TRAILS AT OVERLAND VISION FILING NO. 1

JR RESPONSE: UPDATED TO MATCH COA ITEM #4

TRAILS AT OVERLAND RANCH - SITE PLAN 1

TYPICAL PRODUCT C HOME LOT DETAIL

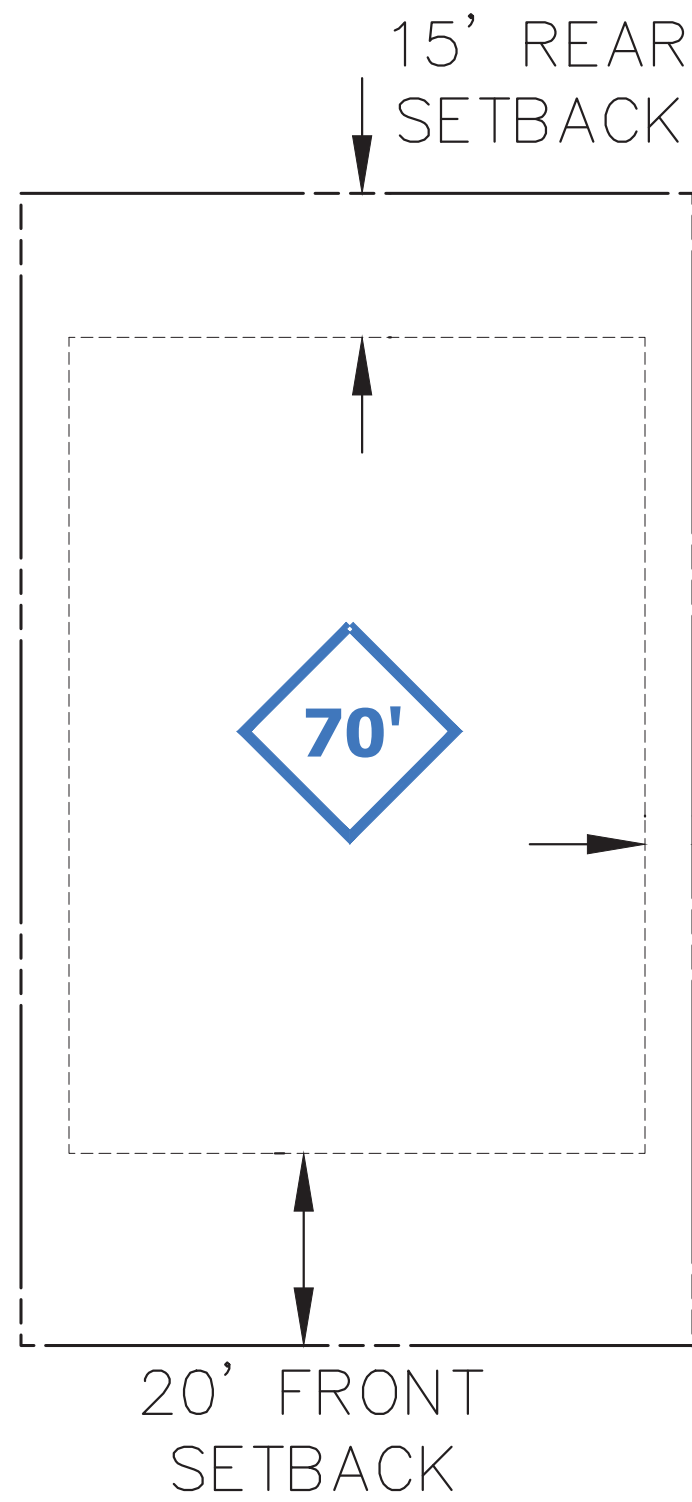
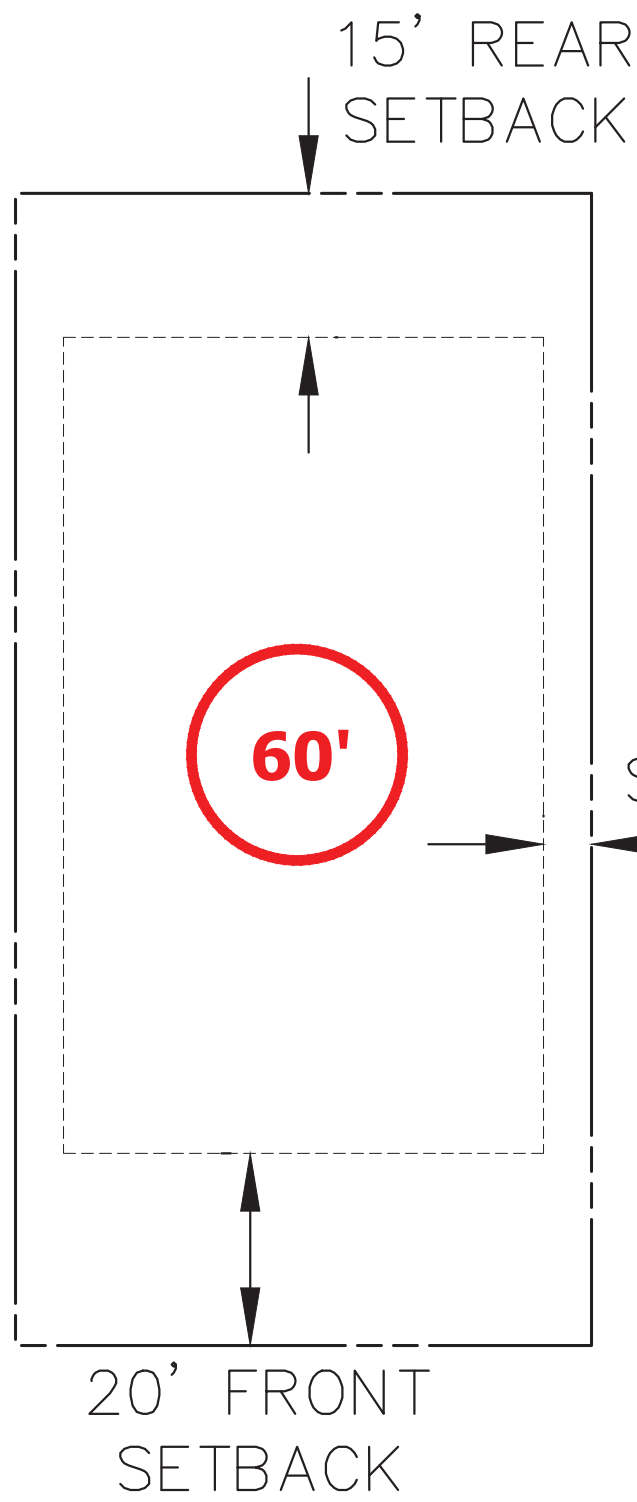
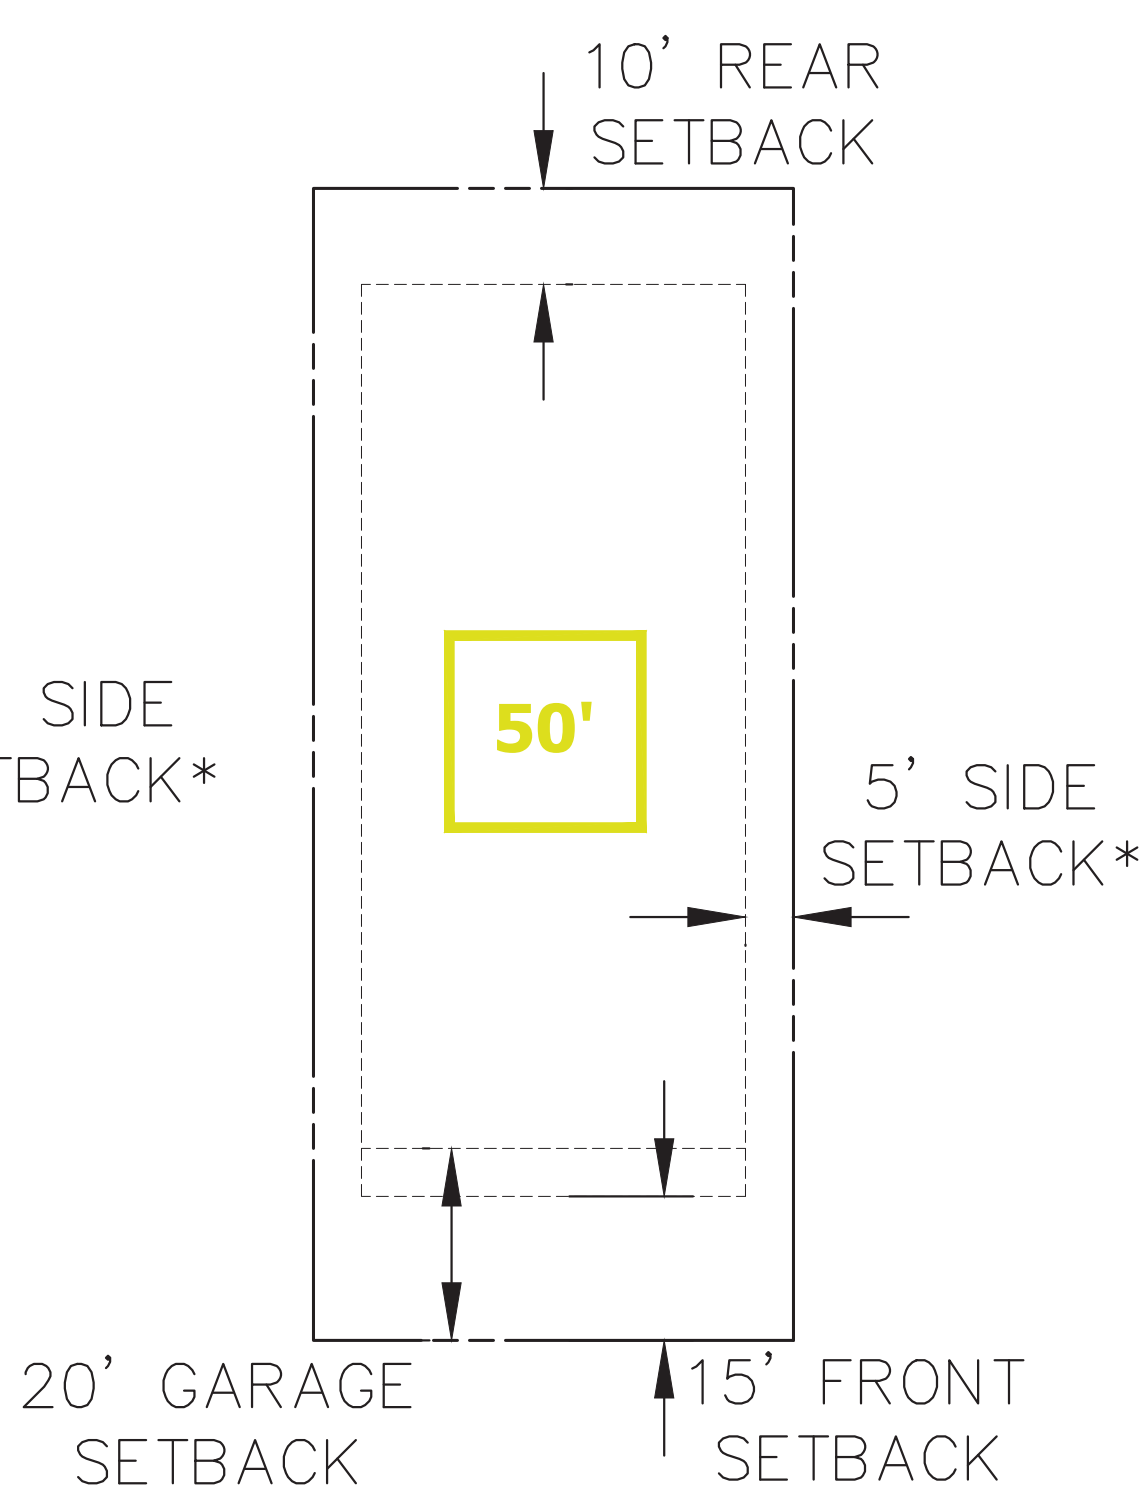
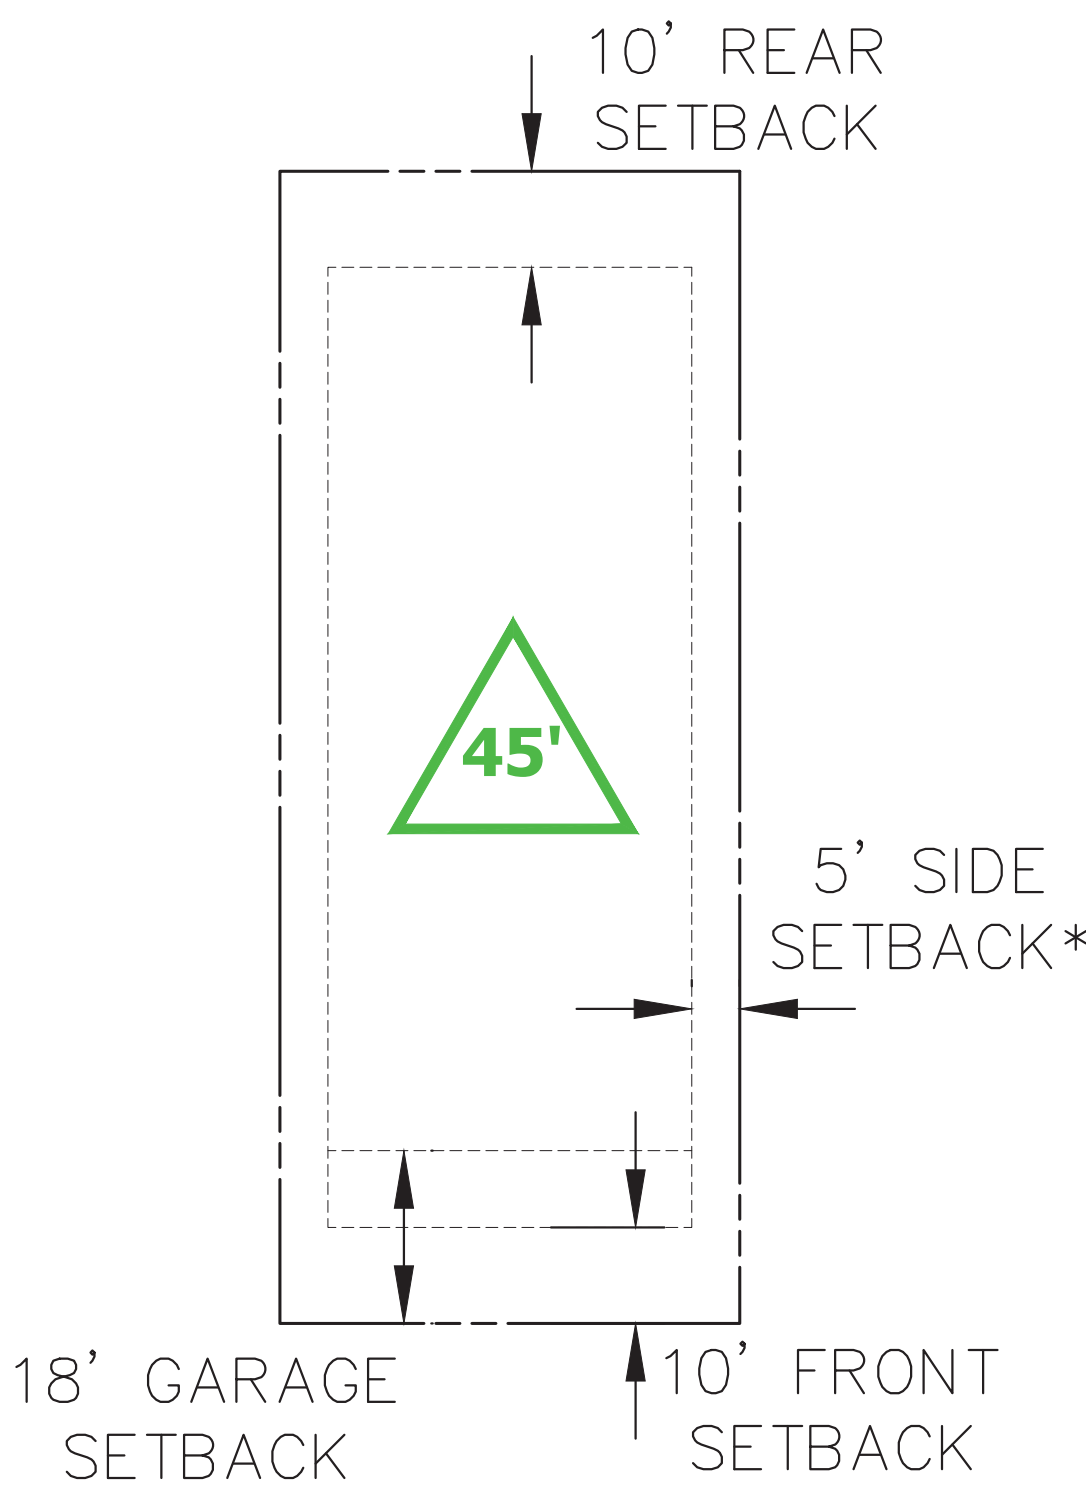
Public streets shall have public streetlights in conformance with COA standards. Please provide the information below in some capacity for the photometric analysis.

For each street, identify the following information as part of the site plan submittal in conformance with Section 2.12.0.1 of the Roadway Manual:

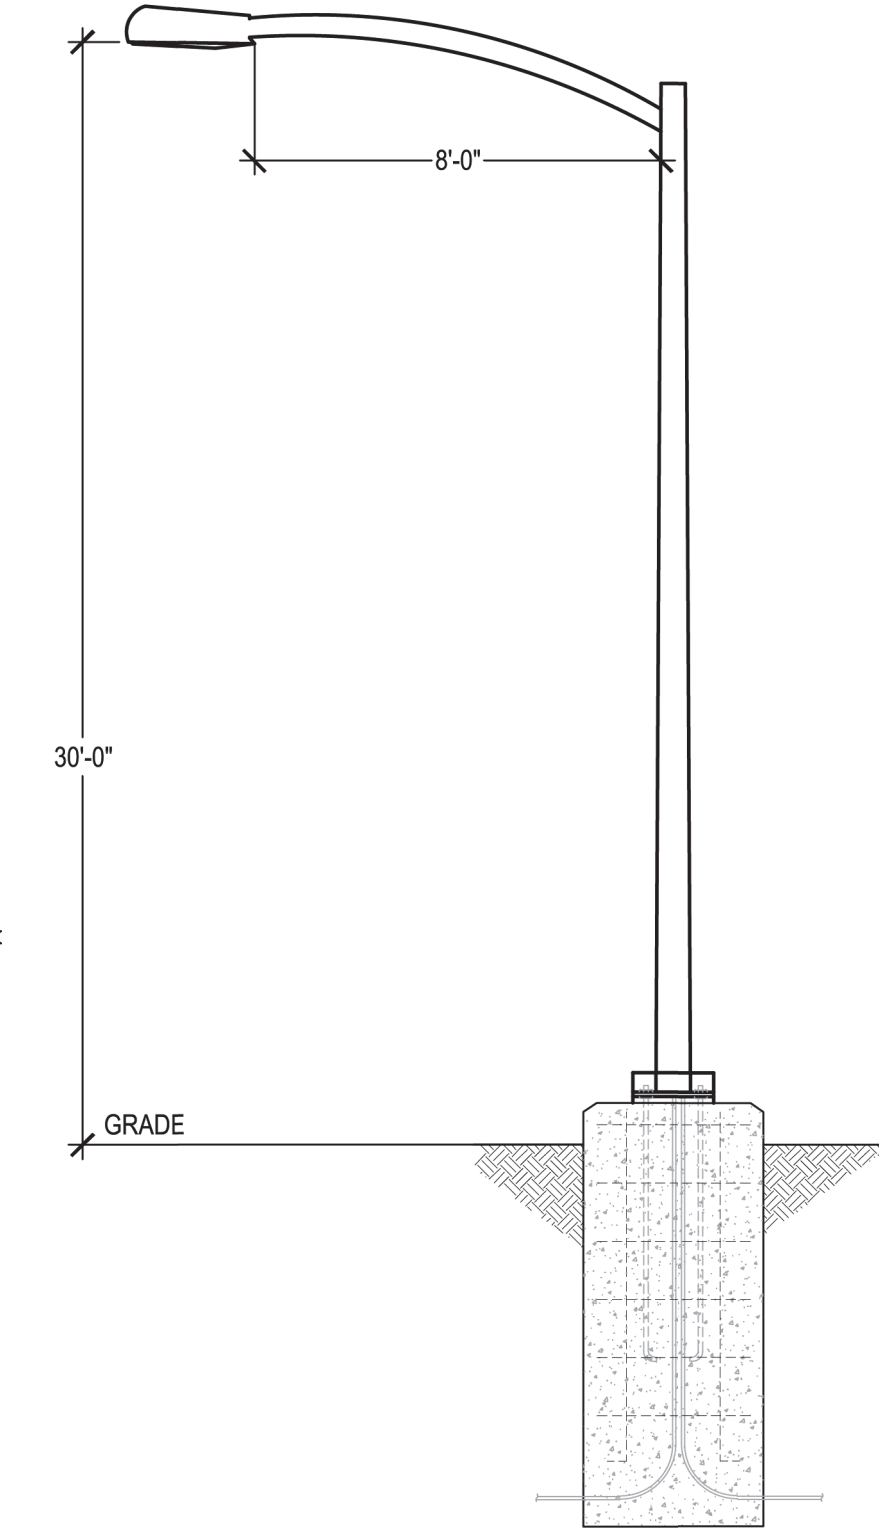
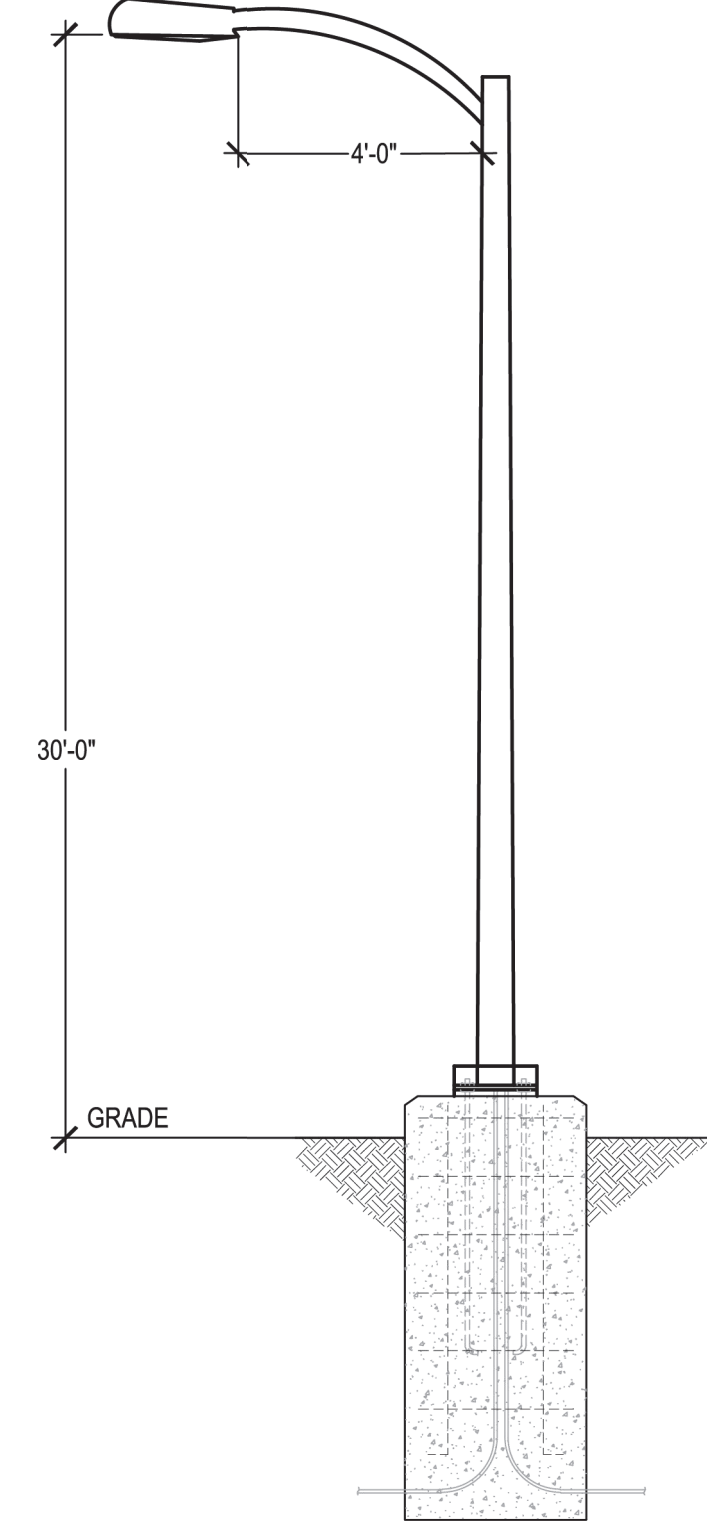
Show railing on the wall sections, typical.

Response:
Railings added to the details.

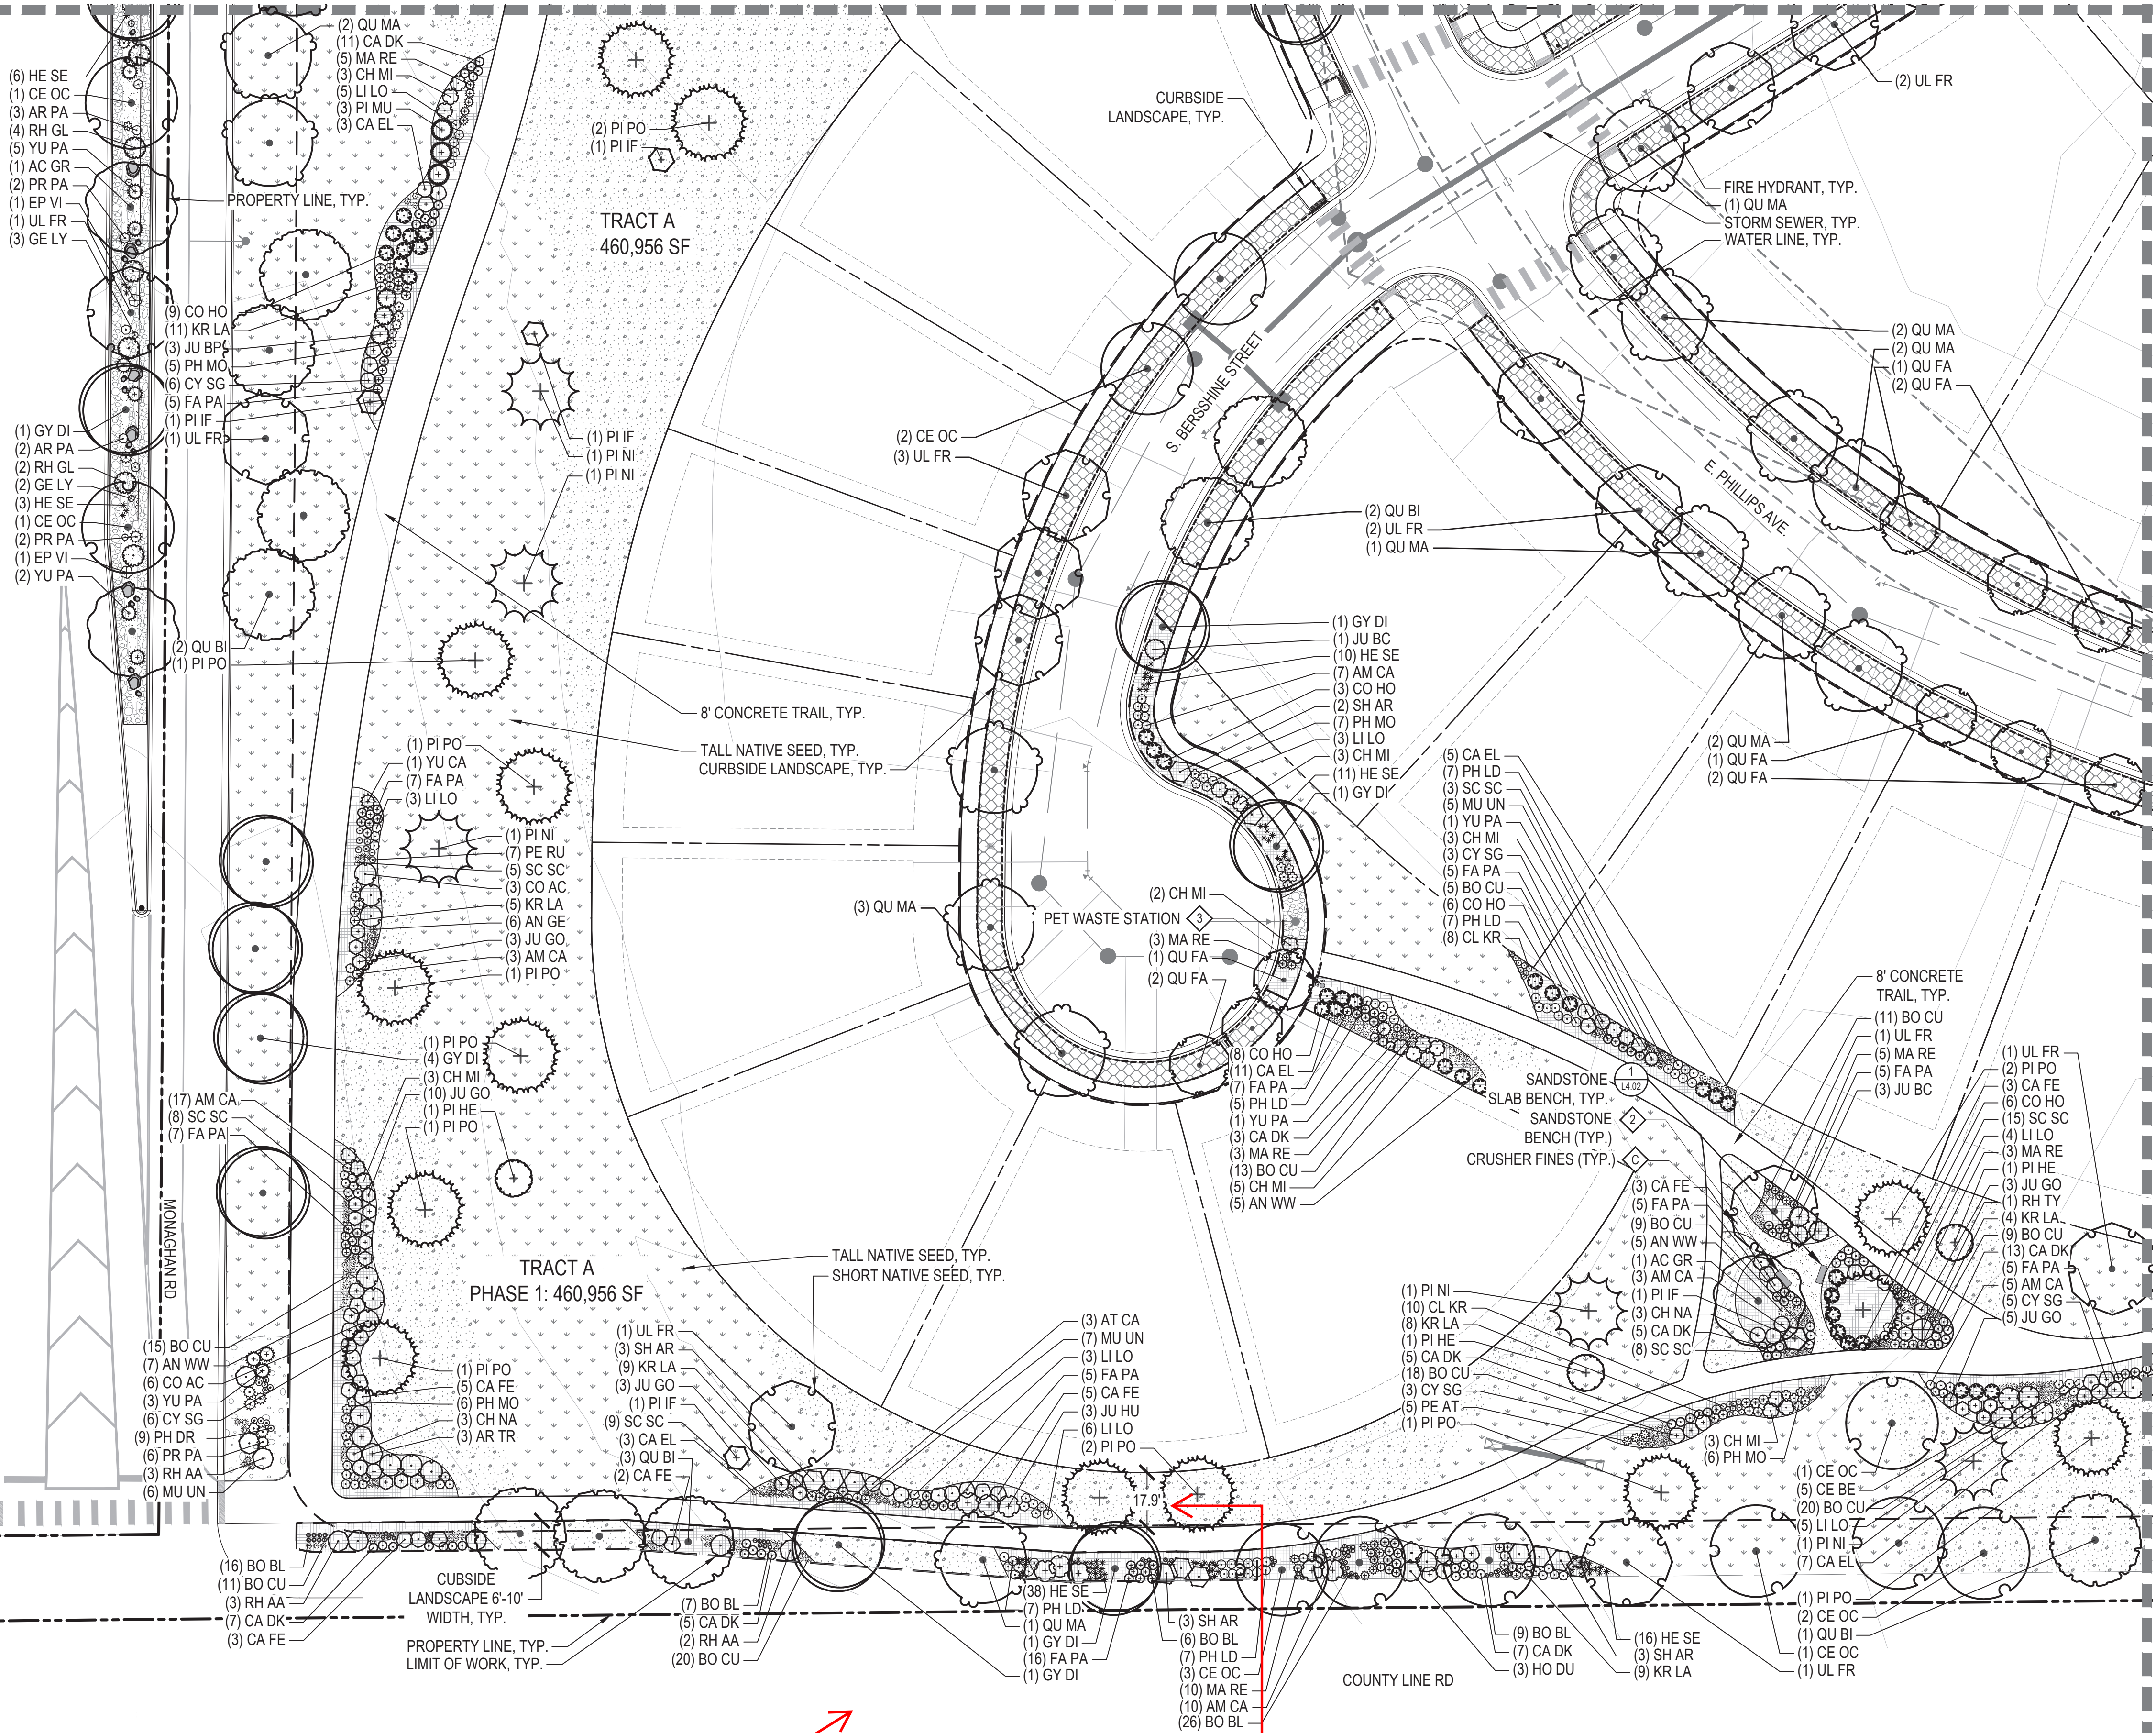
Include County Line Road so the landscaping is not floating on the sheet and it has context.

COUNTY LINE ROAD LINEWORK HAS BEEN ADDED. -NORRIS DESIGN
